Interactive comment on “Imaging tropical peatlands in Indonesia using ground penetrating radar (GPR) and electrical resistivity imaging (ERI): implications for carbon stock estimates and peat soil characterization” by X. Comas et al.

Received and published: 17 April 2015

Also, we are including two versions of the new manuscript, one annotated and showing the changes to the previous version, and a clean one with all changes accepted. Additionally a total of 4 figures have been modified following some of the comments from the reviewers and are also attached here.

Fig. 1.

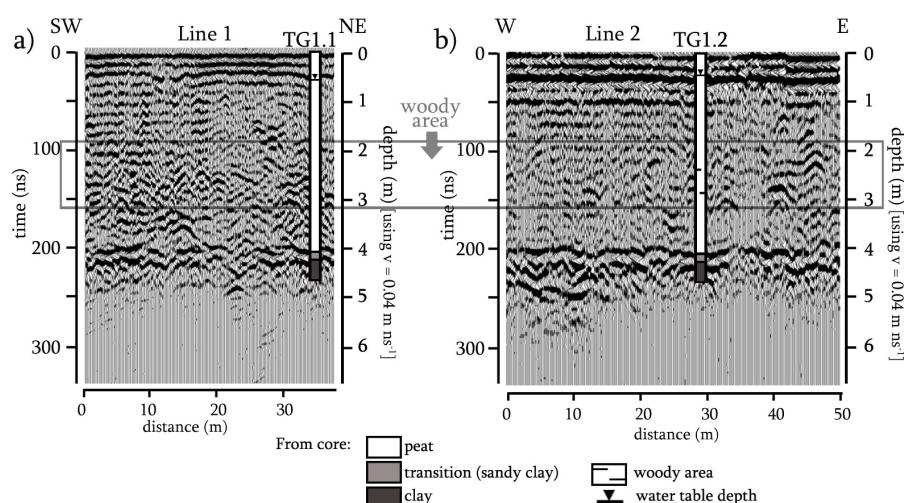
- 7. Figure 2: What is "woody layers"? In order to avoid confusion, the term "woody layer" in Figure 2 has now been replaced with "woody area" as explained in the text (section 4.1).

-8. Figure 2 and 5, 6: Water table elevation is water table depth "Water table elevation"

has been replaced with "water table depth" in all figures.

Fig. 2.

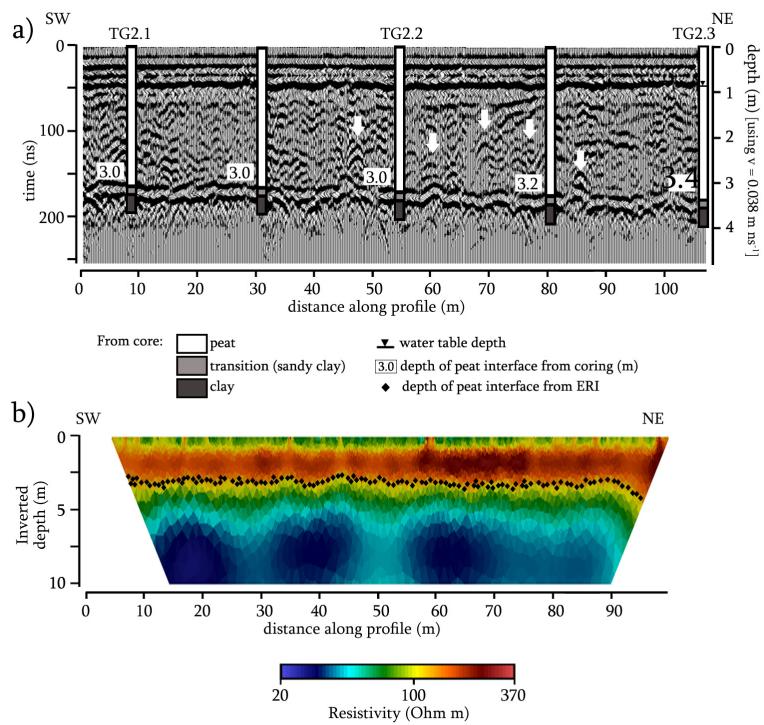
- 2. In Figure 5 (a), "TG2.1-TG.3" is misspelled and "3.4 m" is too large. Misspelling in the legend is now corrected. We do not however understand the reference to 3.4 m being too large. This reading corresponds to the depth of the peat-clay interface as detected from coring.

Fig. 4.

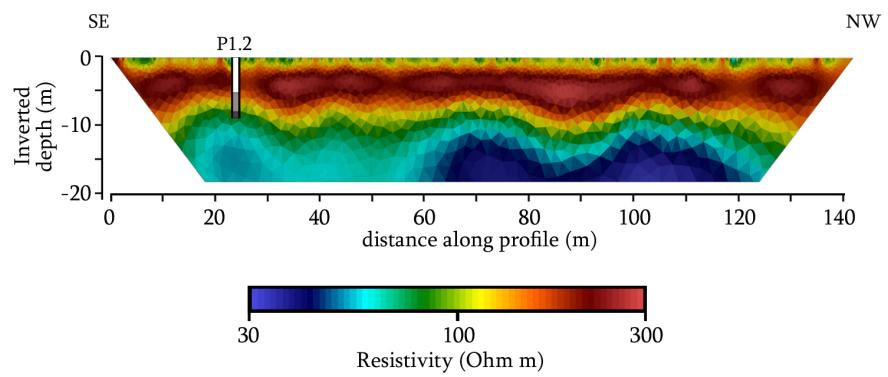
- 3. In Figure 7, what does black diamond mean? Black diamonds have now been removed from the figure.
